3.3 LIMITING SAFETY SYSTEM SETTINGS

Fort St. Vrain #1
Technical Specifications
Amendment #
Page 4.4-7

ATTACHMENT 3

Background: By letter dated June 21, 1985, the Public Service Company of Colorado (the licensee) proposed changes to Technical Specifications for the Fort St Vrain Nuclear Generating Station. The primary purpose of the proposed changes was to modify the trip setpoints for the Plant Protection Systems (PPS) such that the values specified included a sufficient allowance for uncertainties associated with the instrument systems. Currently, the setpoints for the PPS are specified at the values for which the safety analysis assumed mitigative actions would be initiated. The proposed changes result in revised trip setpoints that include an additional margin of conservatism to account for instrumentation uncertainties. The revised trip setpoints were determined using Instrument Society of America Standard S67.04-1982, "Setpoints for Nuclear Safety-Related Instrumentation Used in Nuclear Power Plants" as guidance.

FIGURE 3.3-1
HIGH NEUTRON FLUX SCRAM
DETECTOR DECALIBRATION
CURVES FOR CYCLE 4

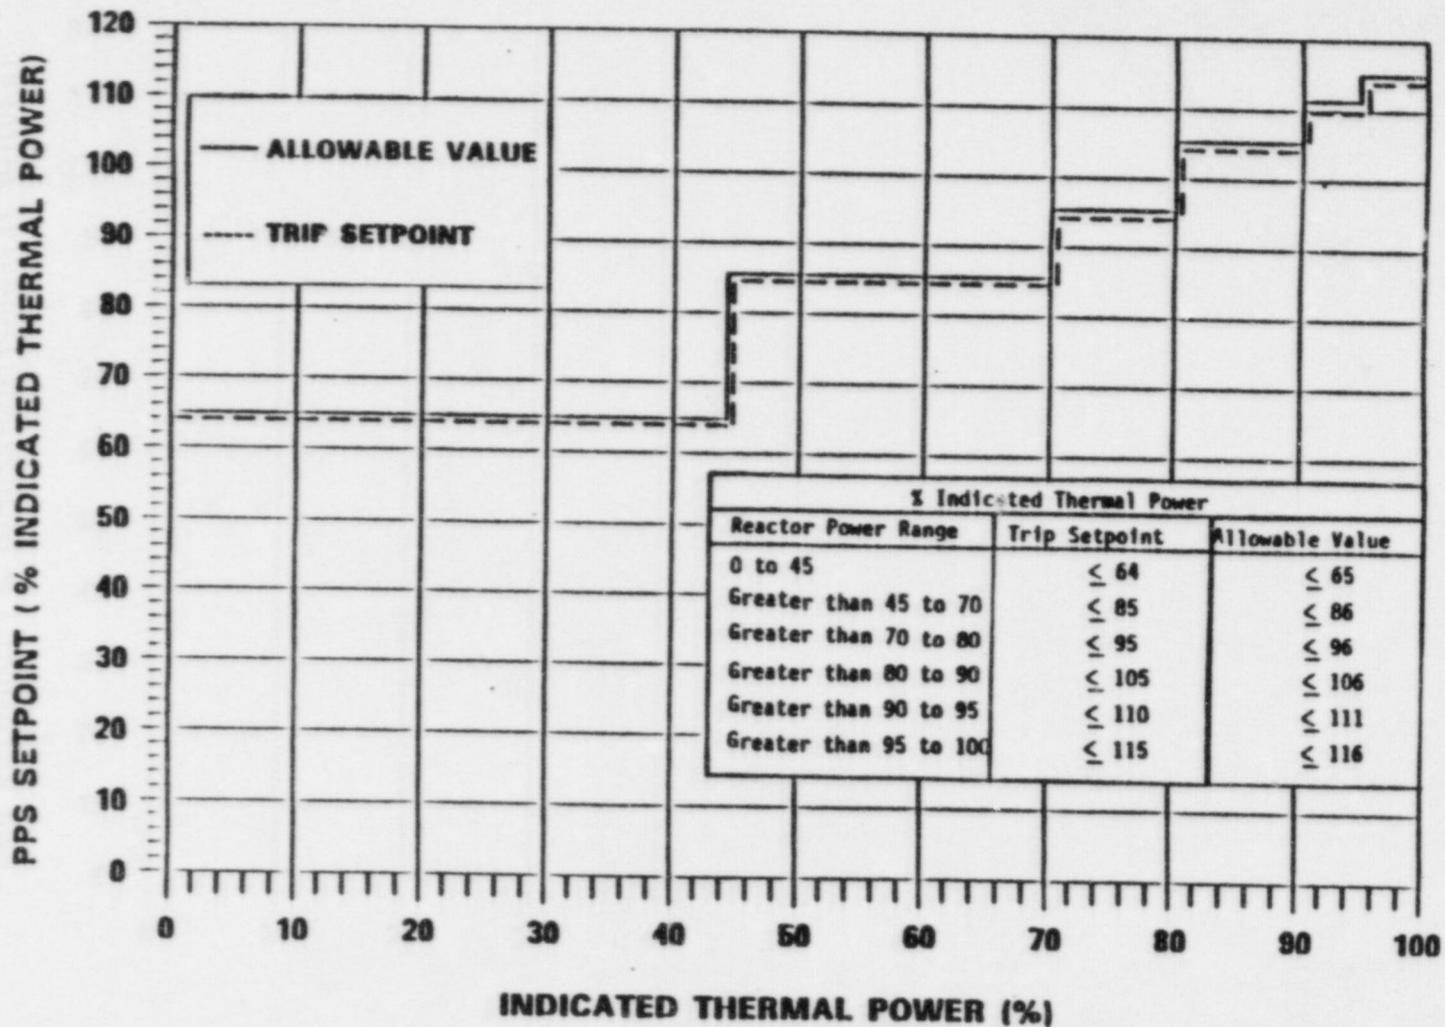
The setpoint for the high neutron flux scram is 140 percent of rated thermal power. As a consequence of uncertainties in the reactor power measurement, the setpoint for the high neutron flux scram has been administratively controlled and adjusted at conservative values based on indicated reactor power. The licensee provided curves that are currently being used to control the setpoint for the high neutron flux scram as well as the high neutron flux rod withdrawal prohibit. Further, the licensee proposed to delete the values for the trip setpoints for the protective actions and to note that these settings are to be established for each fuel cycle and implemented based upon the approval of the Nuclear Facility Safety Committee. The staff finds that this proposal is unacceptable; therefore the curves which define these setpoints ^{must be retained} ~~have been included~~ in the Technical Specification requirements.
